**SERVICE BULLETIN SB FSG2T-1.06**

**TYPE DESIGNATION** FSG 2T VHF/AM Airband Transceiver – Part number F10350

**REASON** Possible degradation of operational availability could create disruption of VHF communication due to internal capacitor misplacement. The capacitor could be destroyed and could be separated with possible generation of smoke.

Fig. 1: TX/RX Module with misplaced Capacitor C2038

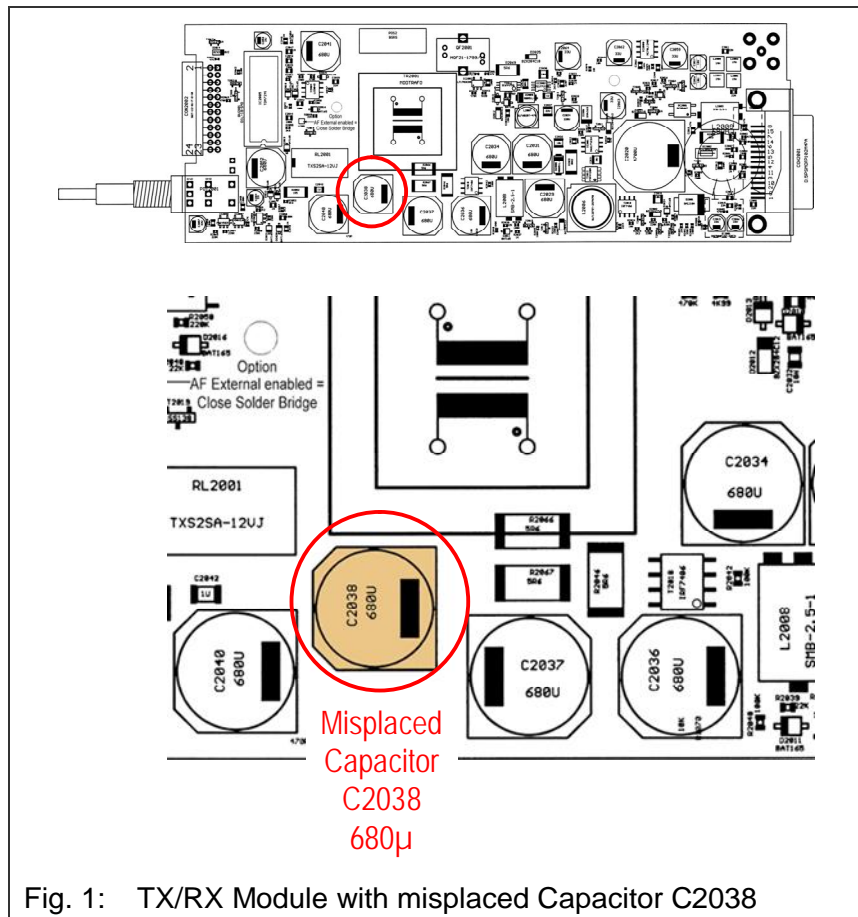
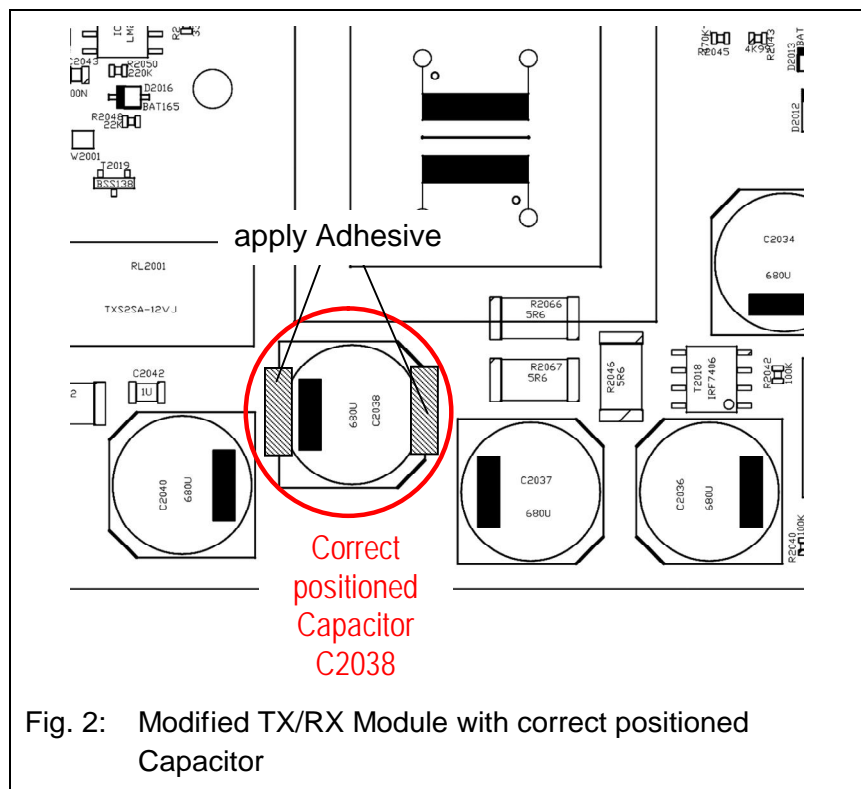
**DESCRIPTION** Replace the misplaced capacitor by a new capacitor placed as shown in the attachment. To have access to the capacitor it is necessary to open the unit and to separate the TX/RX Module from the Chassis. Remove the adhesive fixing and replace the SMD capacitor.

Locate the misplaced capacitor C2038 (680µ) on the TX/RX Module.

- Repair:
- An adhesive fixes the capacitor C2038. Use a regulated heat gun (ca. 300°C / 570°F) with a small nozzle to warm up the adhesive.
  - Scratch off the adhesive.
  - Use an adequate solder tip to unsolder the misplaced capacitor.
  - Clean the soldering pads.
  - Take the supplied NEW capacitor C2038, 680µ and position it (watch polarity/marker!).
  - Solder.

Fig. 3: Position of Mod-Index Label

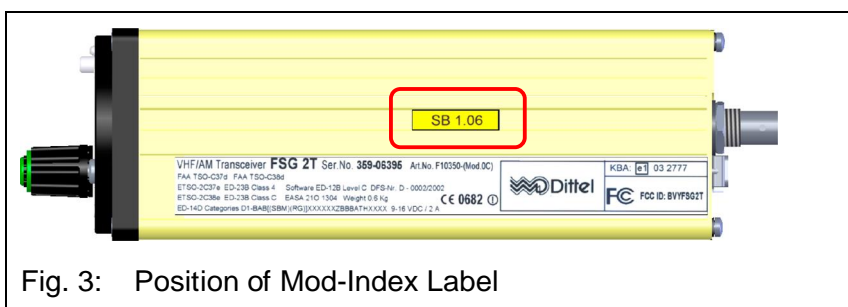
After meeting the required minimum performance values mark the transceiver FSG 2T with the supplied Mod-Index label
